Land Development and Transportation Committee
Staff Report
February 28, 2019

Case No:	18SUBDIV1016
Project Name:	The Woods of Brookshire
Location:	6302 Rocky Mountain Dr.
Owner(s):	EG Properties, Inc.
Applicant:	H&T Realty Co.
Jurisdiction:	Louisville Metro
Council District:	23 – James Peden
Case Manager:	Jay Lockett, AICP, Planner I

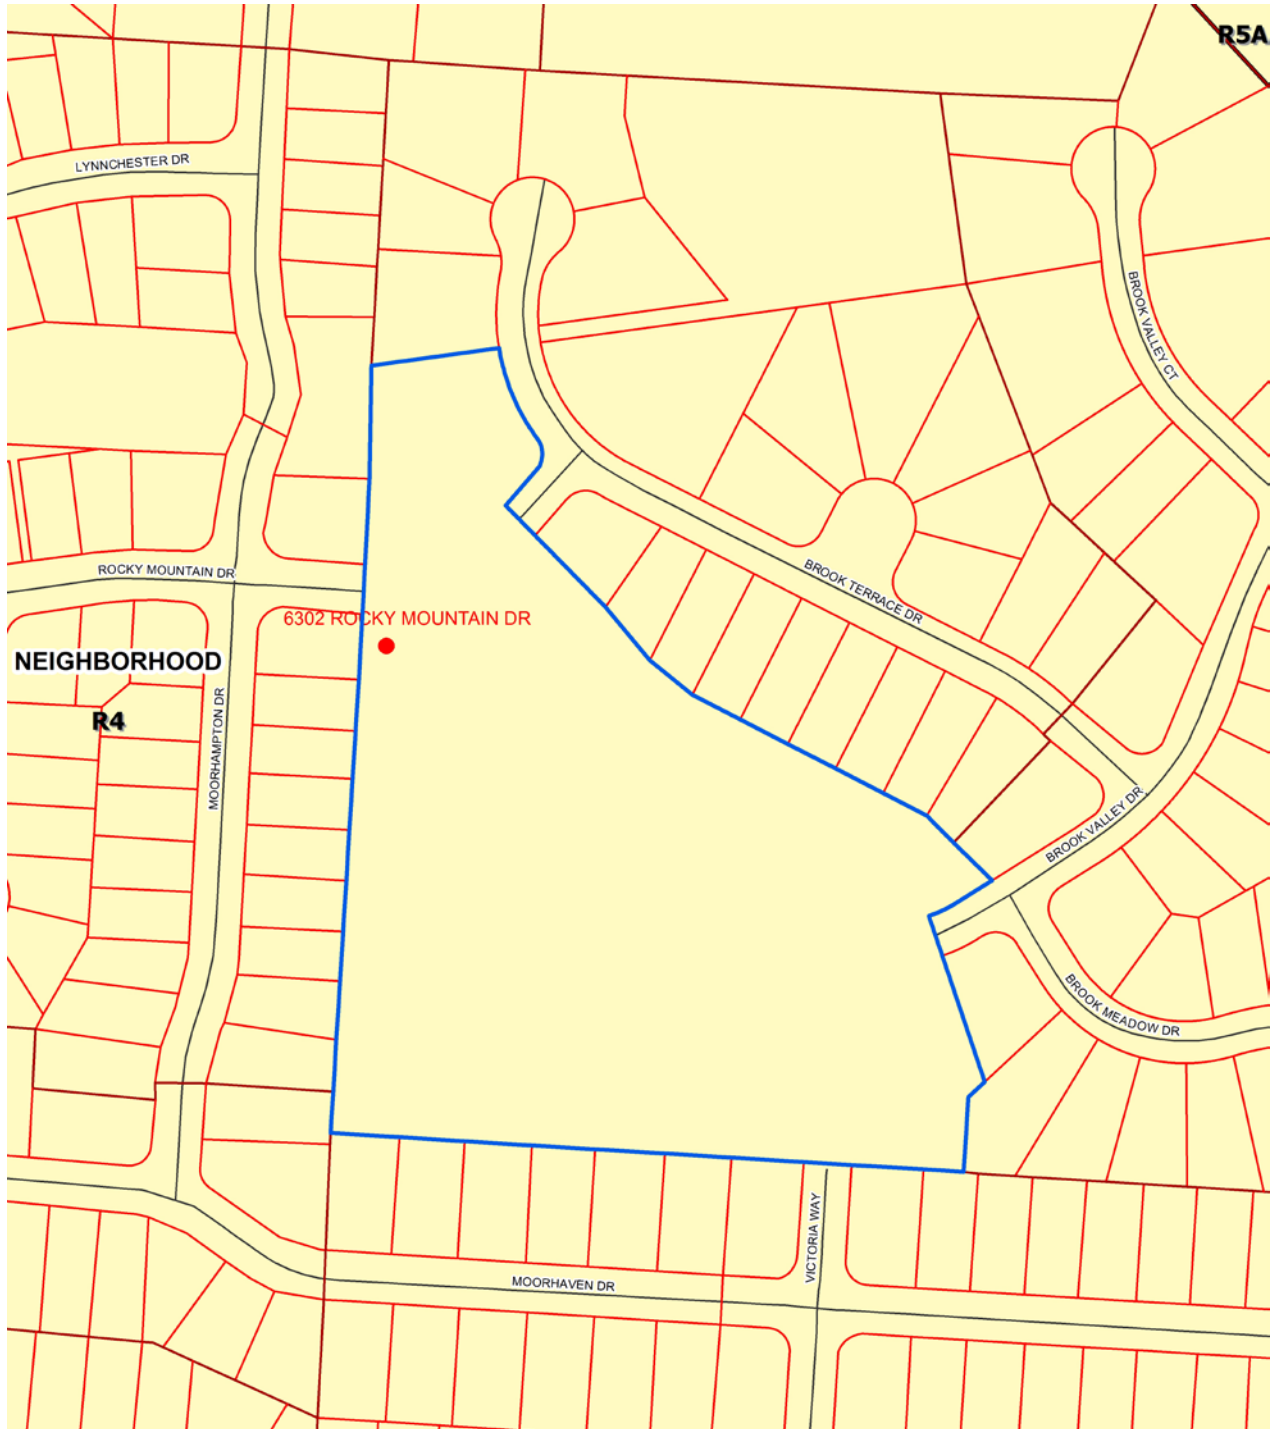
There are two adjacent stub streets that will need to be renamed per Metrosafe recommendation to avoid future confusion that would result from streets changing names mid-block.

16. Prior to recording the record plat, the applicant shall record a street name change for the section of Victoria Way north of Moorhaven Dr to Brook Valley Dr.

17. Prior to recording the record plat, the applicant shall record a street name change for the section of Rocky Mountain Dr south of Brook Terrace Dr to match the final approved name for "Court A."
